COMMITTEE OF THE WHOLE NOVEMBER 18, 2002

**BLOCK 11 BLOCK PLAN
NINE-TEN WEST LIMITED ET AL
BLOCK FILE: BL.11.2001**

Re: Block 11 - Master Environmental Servicing Plan
City File BL.11.2001
Lots 16-20, Concession 2 WYS
City of Vaughan (Nine-Ten West Limited et al.)

ATTACHMENT '4'		FILE #:	REPORT #:	DATE:
RED-LINED		BL.11.2001	LOCATION:	11/12/2002
BLOCK PLAN		LOTS 16 TO 20, CONCESSION 2	CITY OF VAUGHAN	SCALE: NOT TO SCALE
			PLANNING DEPARTMENT	APPLICANT:
			NINE-TEN WEST LIMITED, ET. AL

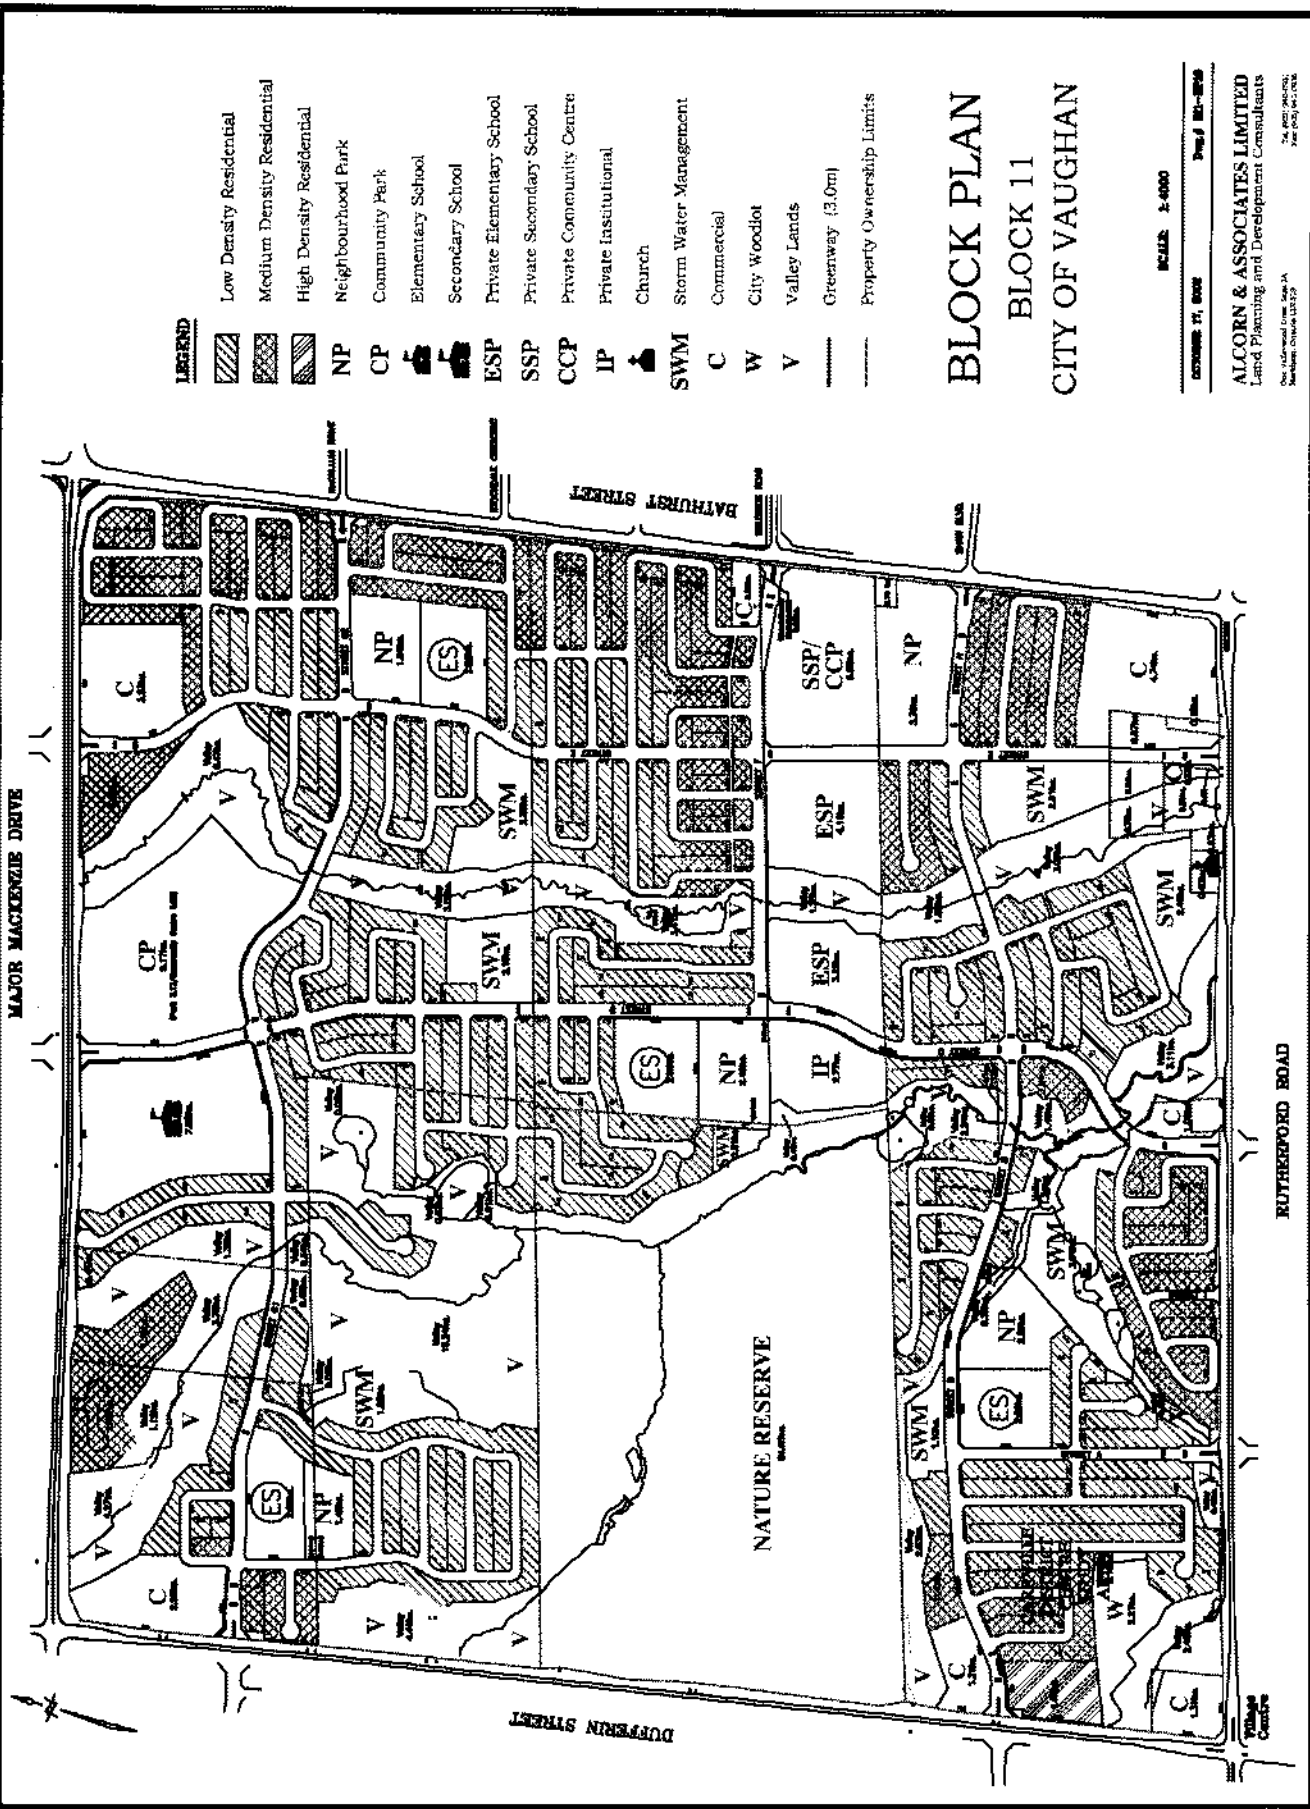
- A) The Block 11 Block Plan, dated October 17th, 2002, as red-lined, BE APPROVED, subject to the following conditions:
- 1.(i) a) That the proposed neighbourhood commercial site at the northwest corner of Rutherford Road and Bathurst Street be modified to incorporate a single loaded road immediately north of the said site to improve access and minimize land use conflicts with the residential uses proposed adjacent to the commercial site; and, that a commercial needs assessment be completed to determine the appropriate size of this site.

- b) That the internal road pattern surrounding the proposed neighbourhood commercial site at the southeast corner of Major Mackenzie Drive and the N/S primary road be reconfigured to incorporate a single loaded local road flanking either the easterly or southerly boundary of the site, to improve access and minimize land use conflicts with the residential uses proposed adjacent to the commercial site.

- c) That the neighbourhood park located in the northeast quadrant of the block be reconfigured to eliminate the lotting along Street "G2"; similarly the lotting should be eliminated along the south limit of the proposed District Park as shown on Schedule "4".
